Form C-103
Revised August 1, 2011

WELL API NO.
30-015-22104

SUNDRY NOTICES AND REPORTS ON WELLS
(DO NOT USE THIS FORM FOR PROPOSALS TO DRILL OR TO DEEPEN OR PLUG BACK TO A DIFFERENT RESERVOIR. USE "APPLICATION FOR PERMIT" (FORM C-101) FOR SUCH PROPOSALS.)

7. Lease Name or Unit Agreement Name
Old Indian Draw Unit

Old Indian Draw Unit 24
Proposed Wellbore Diagram

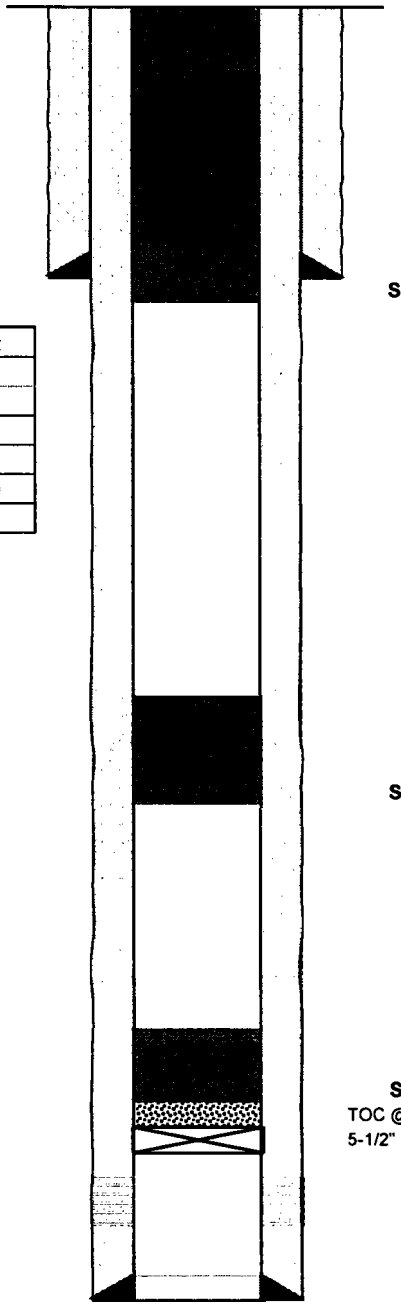
Spot 50 sx CL C cmt f/ 450' t/ surface (Shoe, T. Salt, Fresh Water)

Spot 25 sx CL C cmt f/ 2440' t/ 2212' (Bell Cyn, Lamar, B. Salt)

Spot 25 sx CL C cmt f/ 3119' t/ 2891' (Upgrade Cement)

NOTE: According to TA C-103, only 29' of cmt (3 sxs using yield of 1.32) was put on top of CIBP.

*See Attached COA's 9/17/2018 Must be Plugged by 9-17-19
